Access Compliance Report Public Rights-of-Way (Curb Ramps)

Main Street: MAINWAY_DR Cross Street: MONTECITO_RD Location: NW

ADA ID: RPRK211208122422 Ramp Type: Type 4 - Parallel Initial Pass/Fail: Fail Overall Compliance: No Severity Score: 30

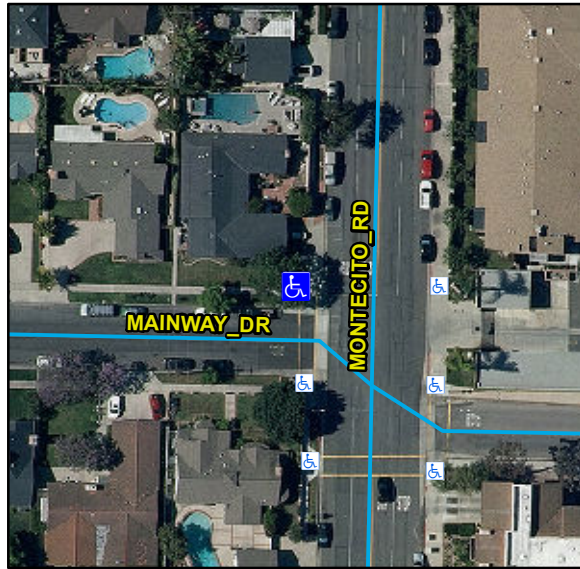
Compliance	Description	Data	Compliance	Description	Data
N/A	Ramp Length LT (in)	90	N/A	Ramp Length RT (in)	85
Yes	Ramp Width LT (in)	115	Yes	Ramp Width RT (in)	115
Yes	Ramp Run Slope LT (%)	7	Yes	Ramp Run Slope RT (%)	4.3
Yes	Ramp Cross Slope LT (%)	1.9	No	Ramp Cross Slope RT (%)	7.5
N/A	Landing Present	N/A	N/A	DWS Provided	N/A
N/A	Landing Length (in)	N/A	N/A	DWS Contrast	N/A
N/A	Landing Width (in)	N/A	N/A	DWS Length (in)	N/A
N/A	Landing Run Slope (%)	N/A	N/A	DWS Full Width	N/A
N/A	Landing Cross Slope (%)	N/A		DWS Offset Type	N/A
N/A	Landing Movement Obstructed?	N/A	N/A	DWS Offset Left (in)	N/A
	Landing Movement Type	N/A	N/A	DWS Offset Right (in)	N/A
N/A	Landing Shared	N/A			
N/A	Clear Space	Yes			
N/A	Clear Space To Crosswalk (in)	N/A			
N/A	Marked Crosswalk 1	Yes	N/A	Marked Crosswalk 2	No
	Crossing 1 Direction	S		Crossing 2 Direction	E
	Marked Crosswalk 1 Width (in)	144		Marked Crosswalk 2 Width (in)	N/A

Remove & Replace Curb Ramp With Two New Directional Ramps or Equivalent.
